DESIGN REVIEW COMMITTEE

August 21, 2024 6:00 PM

**DEPARTMENT OF PLANNING AND ZONING
PLANNER'S REPORT**

RE: Design Review – 3293 Dogwood Drive

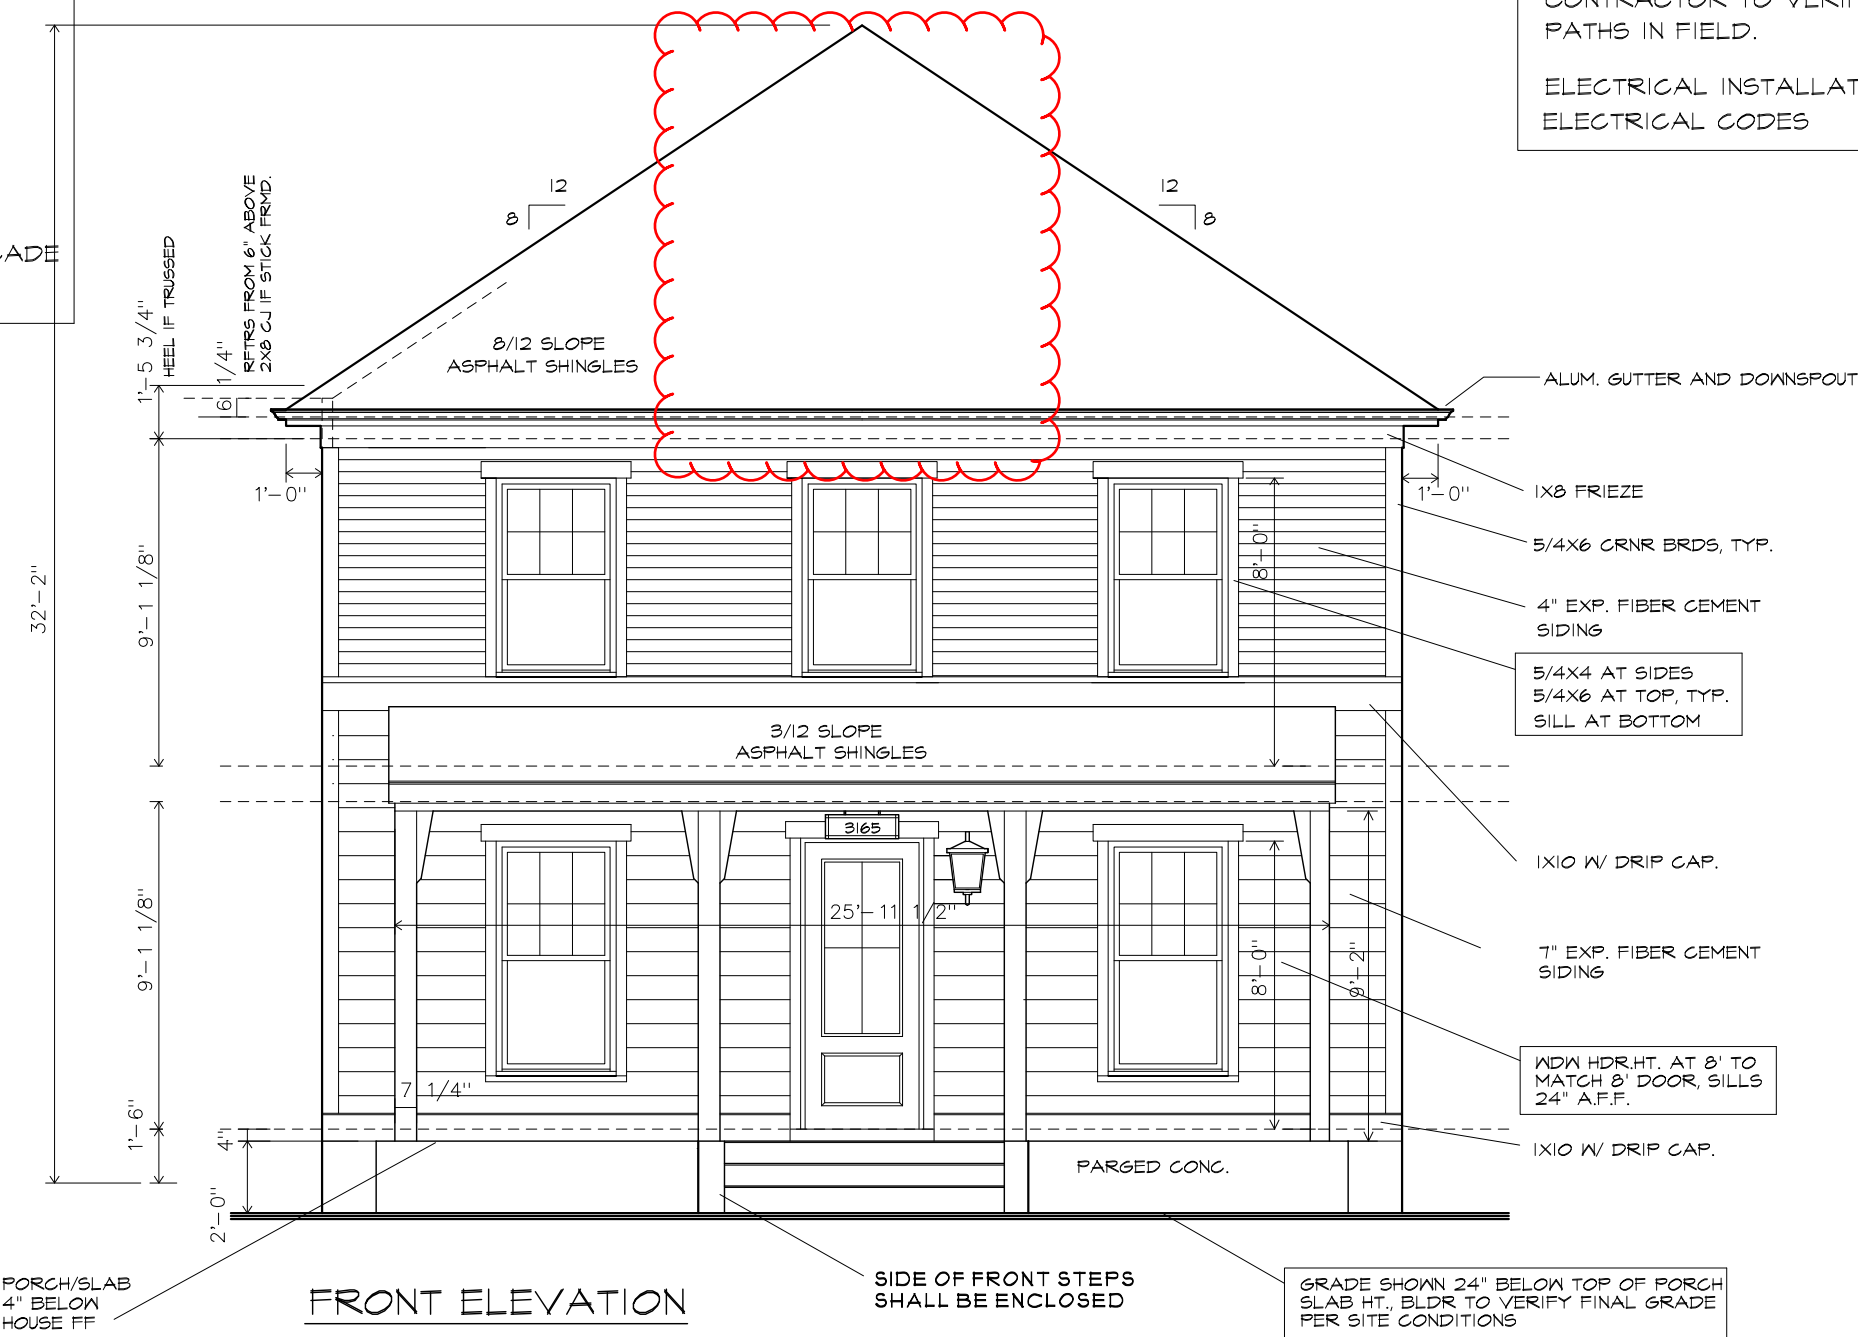
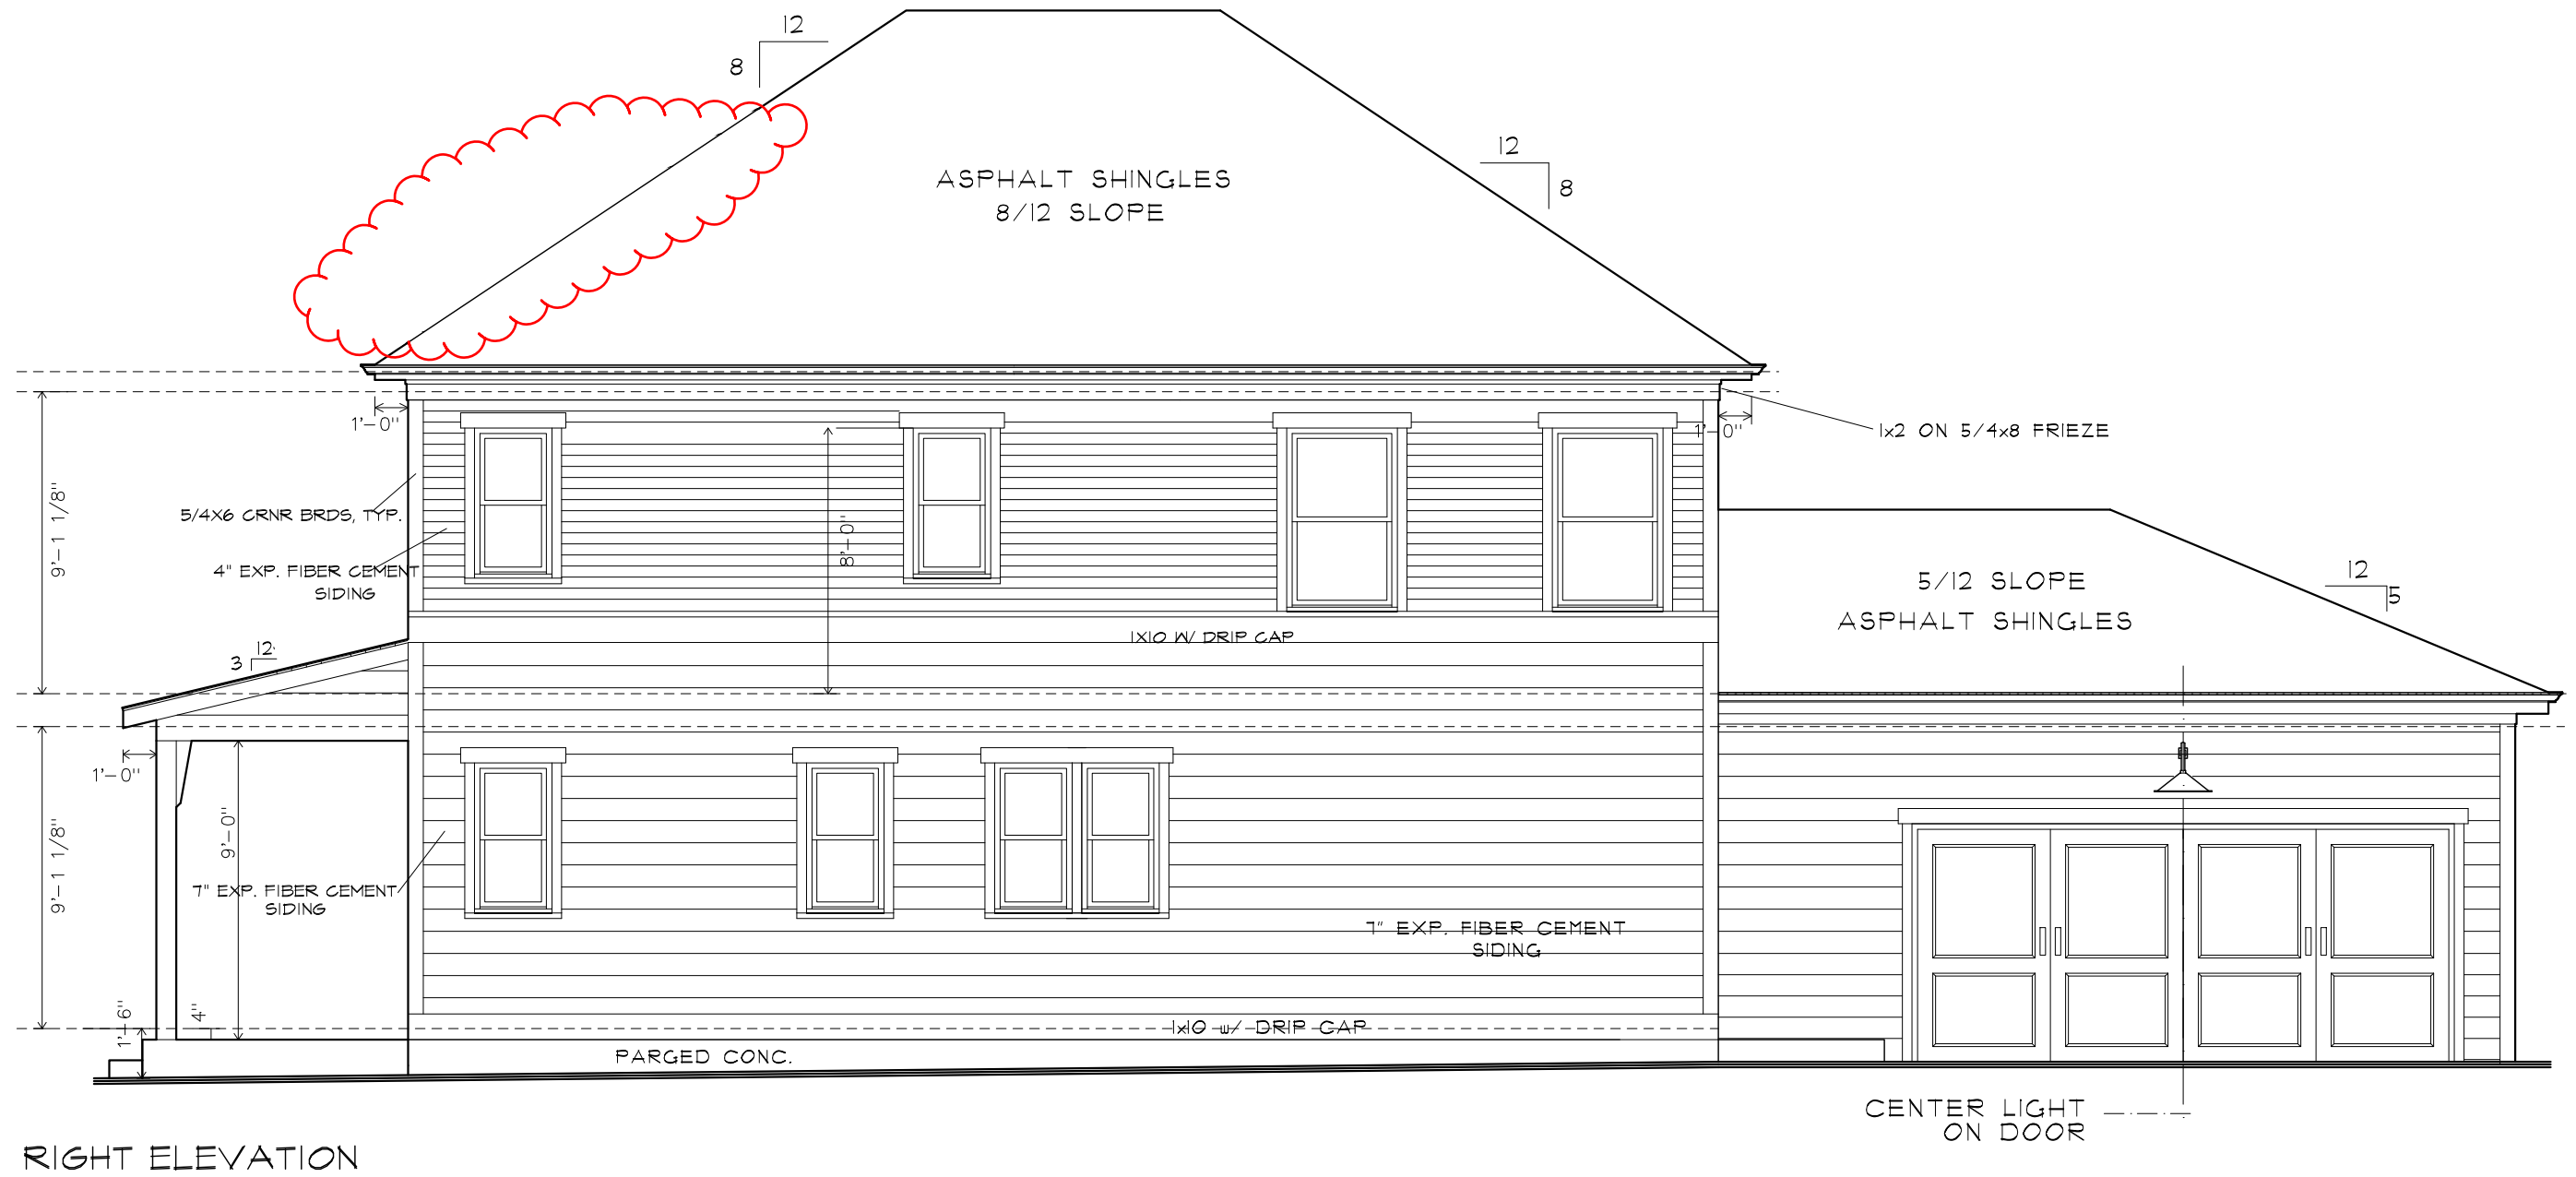
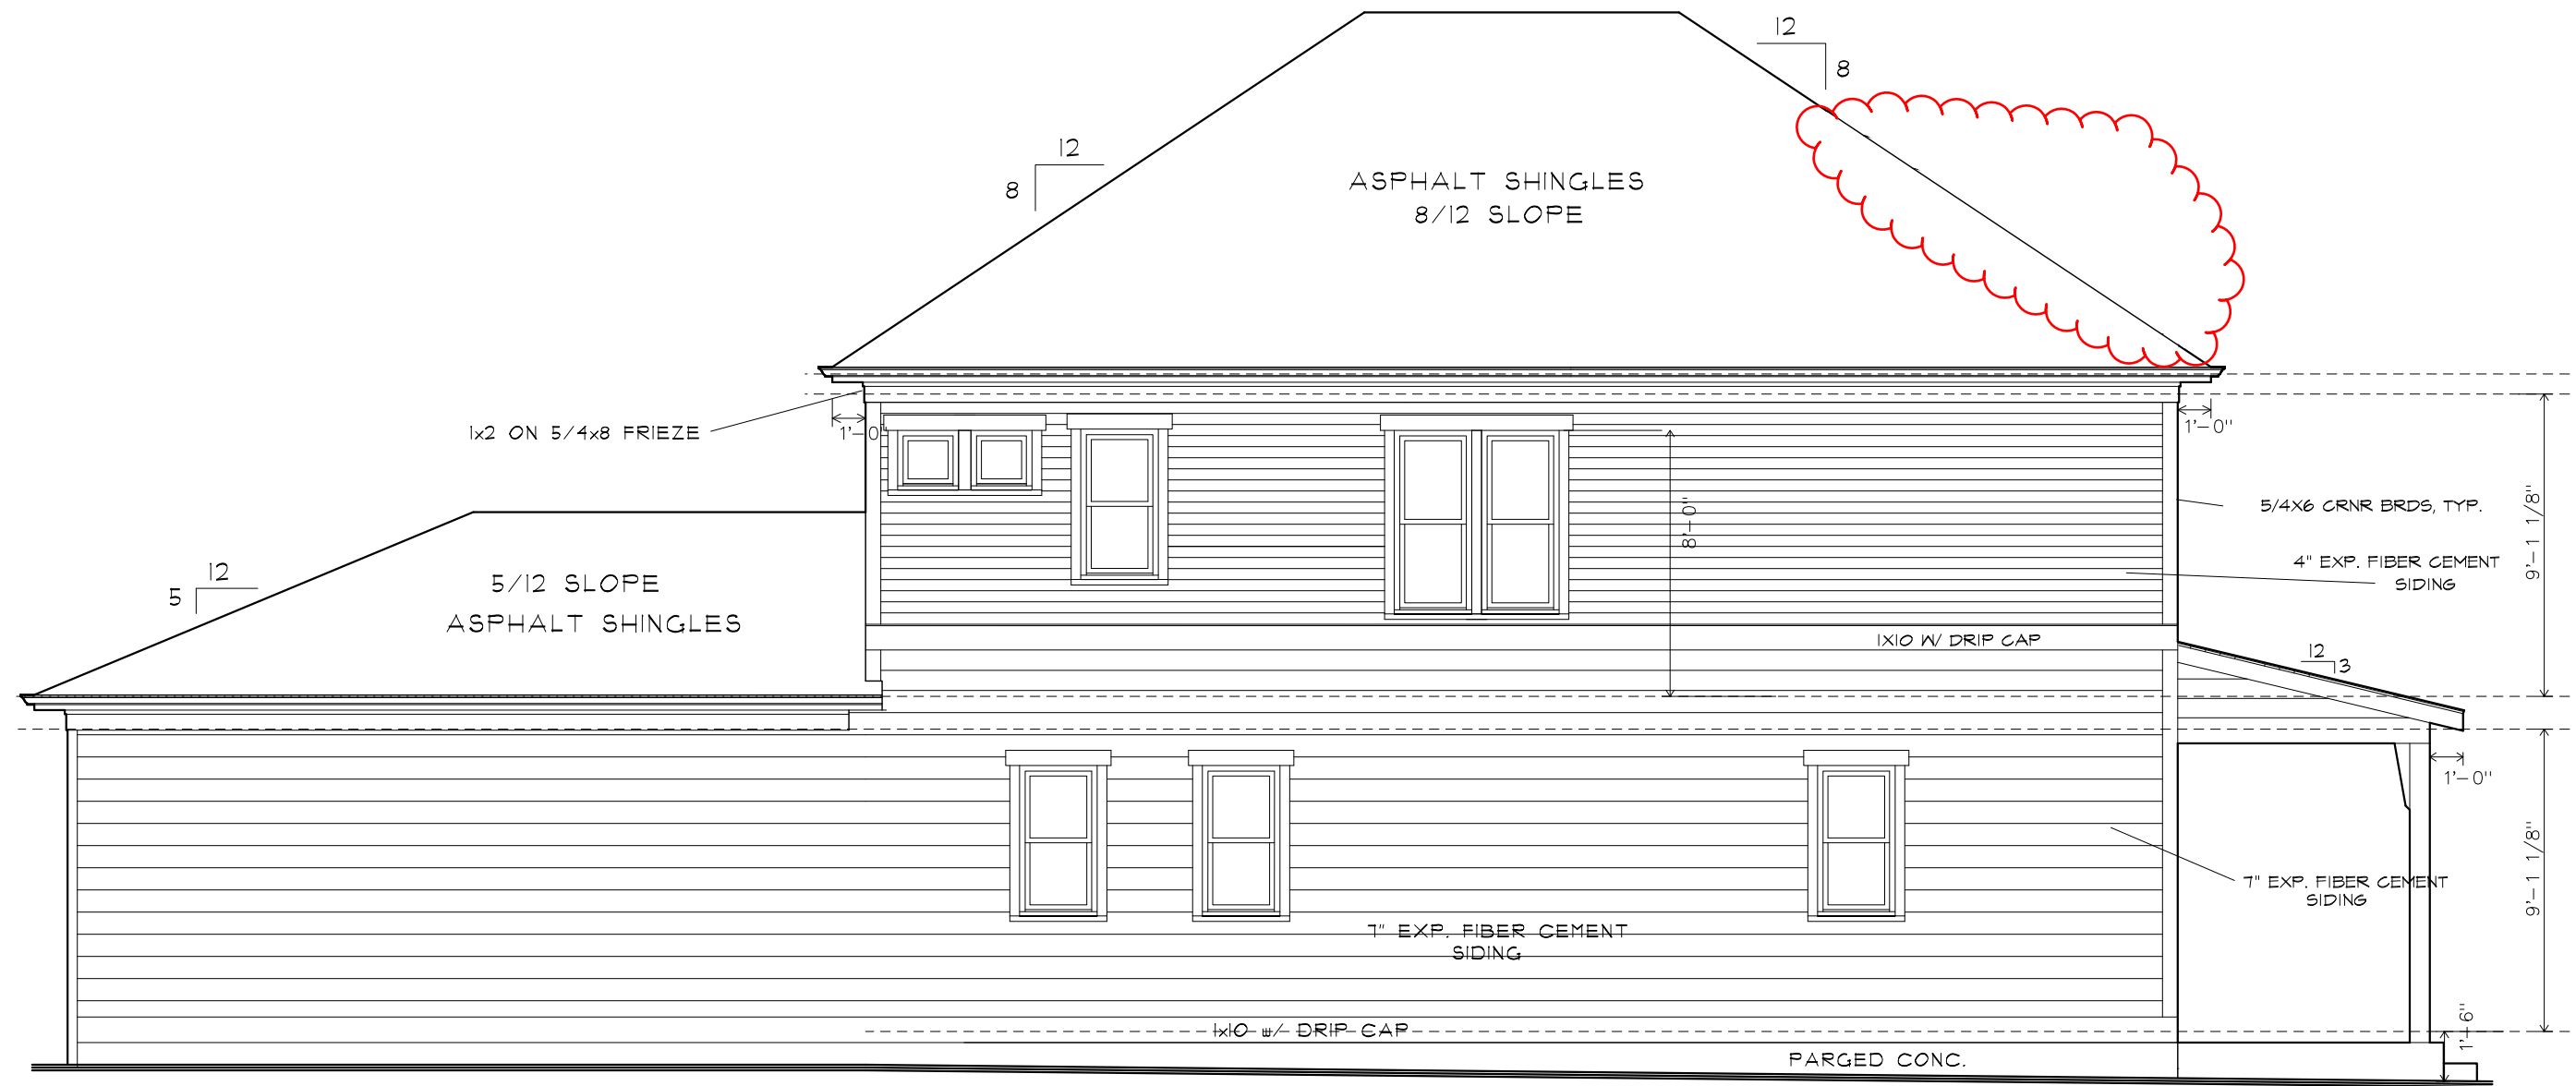
We would like to request changing the front elevation on the home at 3085 Jackson St. to include the dormer that was intended to be on the home at 3163 Old Jonesboro Rd. Please see attached drawings with revisions highlighted. Both floor plans are the same, and they used the plans from lot 3 for lot 2. Shingles were installed prior to catching error. Thank you for your consideration.

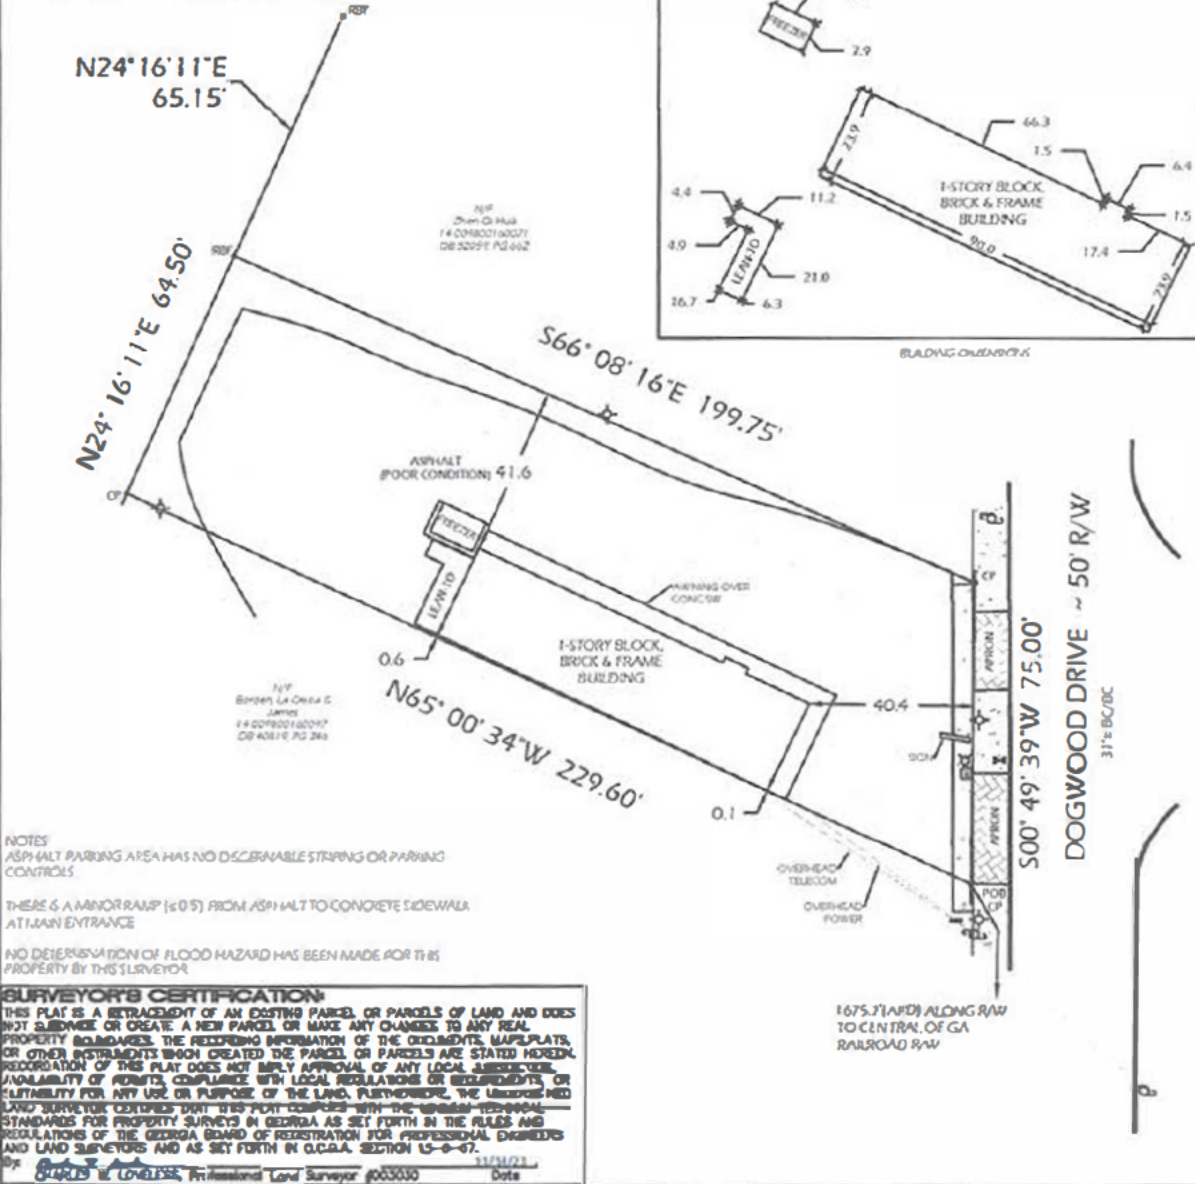
NOTES: *There are no street trees. When the parking lot is improved, the rear buffer could be enlarged to meet the 20' requirement. No dimension is provided for the landscaped buffer. The landscaping at the rear should be maintained to minimize noise and other nuisances. Proposed repaving and striping should be provided to demonstrate parking minimums are met. It is unclear if parking will be located in the front of the building in the supplemental area. The preference for parking is at the rear of the building. Applicant may consider installing fencing, hedging, planter boxes to soften the supplemental area and make is more pedestrian friendly. Design Exception may be required.*

NOTES: *Parking is in the supplemental area and there is no 10' landscape buffer between the parking and the adjacent sidewalk. Design Exception required.*
Driveway existing, design exception required.

PROPOSED FRONT ELEVATION

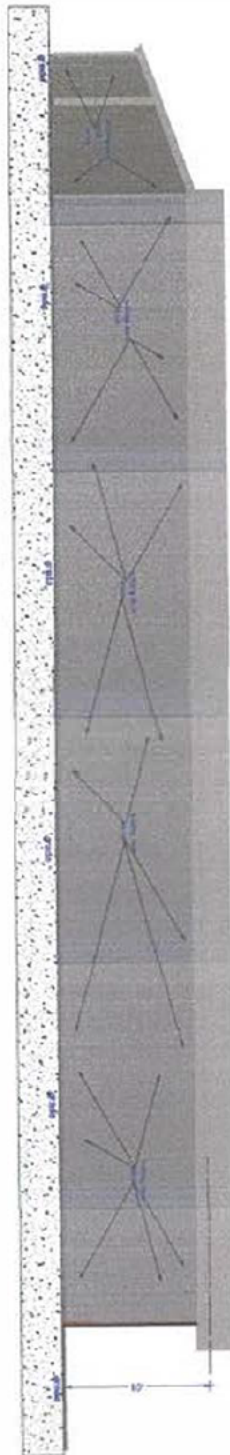
The south elevation (along the property line) does not have windows. A Design Exception is recommended. The foundation on front facade is not distinct. Requires design exception.

NOTES *The existing building is oriented to the side. A design exception is required. There is no pedestrian way from the front door to the sidewalk. A treatment is recommended.*
Building numbers are not shown. Window dimensions (recesses) are not provided.
No transoms are shown. The elevations are not clear - they indicate beadboard on the front facade and not the window as shown on the floor plan. The floor plan also shows one window and the elevations potentially indicated individual window panes. Plans should be corrected. Unknown if there is a drop ceiling.

- 1 There is no pedestrian way from the front door to the sidewalk. A treatment is recommended.
- 2 There are no building numbers shown. Numbers on the enfronting façade and also above the entry door are
- 3 Provide window details including recess and tinting.
- 4 The elevations are not clear - they indicate beadboard on the front facade and not the window as shown on the floor plan. The floor plan also shows one window and the elevations potentially indicated individual window panes. Plans should be corrected.
- 5 Provide building height.
- 6 Indicate if there is a dropped ceiling and height from the window.
- 7 Show downspouts and gutters. Must meet requirements.
- 8 Consider window style to include transoms.
